ARCHITECTURAL REVIEW BOARD STAFF REPORT

Project #/Name	ARB-2023-118: Home Depot Minor Amendment
Review Type	Minor Amendment
Parcel Identification	06100000013100, 06100000013200
Location	1531 Rio Road East (Fig. 1)
Zoned	Planned Development Shopping Center (PDSC), Entrance Corridor (EC)
Owner/Applicant	Home Depot USA Inc./Williams Mullen (Valerie Long)
Magisterial District	Rio
Context	The project is located at the north end of the Fashion Square Mall. A mix of commercial and office buildings is found nearby.
Proposal & Visibility	The applicant proposes demolishing the Sears store and a portion of the north end of the Fashion Square Mall and building a new wall at the northern end of the mall, as a preliminary step to building a new Home Depot store. The proposed wall measures approximately 350' long with four steps in height along its length, ranging in height from 18' to 25'. There are vertical joints in the EIFS at intervals varying from approximately 16' to 27' in width. The proposed mall wall will be visible from the ECs until the Home Depot store is built. It will be visible from Rt. 29 at an angle and more directly from Rio Rd., though at a distance from both locations, with

Figure 4: Aerial view of a portion of the Fashion Square Mall. The highlighted block shows the area of the mall to be demolished. The blue line identifies the location of the new mall wall.

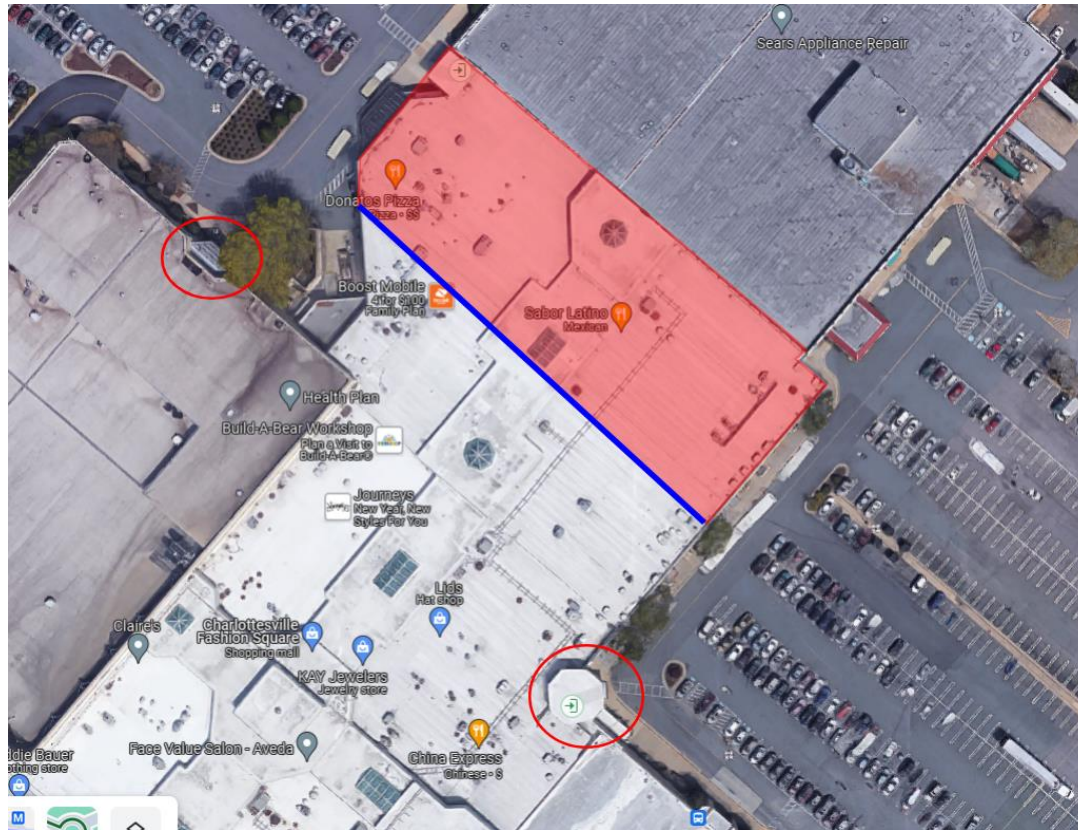
12	Architecture proposed within the Entrance Corridor should use forms, shapes, scale, and materials to create a cohesive whole.		
11	The overall design of buildings should have human scale. Scale should be integral to the building and site design.	The new mall wall is nearly completely blank. The elevation includes an entrance with a utilitarian appearance at the west end of the elevation. Vertical joints are provided in the EIFS surface at intervals varying from approximately 18' to 25' in width. The entrance and joints are not sufficient to relieve the blankness of the wall.	
13	Any appearance of "blankness" resulting from building design should be relieved using design detail or vegetation, or both.		
14	Arcades, colonnades, or other architectural connecting devices should be used to unify groups of buildings within a development.	The proposal separates the Home Depot store from the remaining mall structure and places a travelway in between. Given the mass and scale of the structures, the separation can be considered a positive feature of the proposal.	None.

1. The blankness of the proposed mall wall

1. Revise the design of the new mall wall to relieve blankness using architectural features, articulation, and/or landscaping compatible with that found in the existing building.
2. Revise the architectural drawing to identify a paint color and corresponding Pantone number for the new wall or note that the color will match the color of the adjacent mall wall.
3. Indicate if new lighting is proposed with the new mall wall. If it is, show it on the plan and provide details for review.
4. Show tree protection fencing at individual trees to remain.
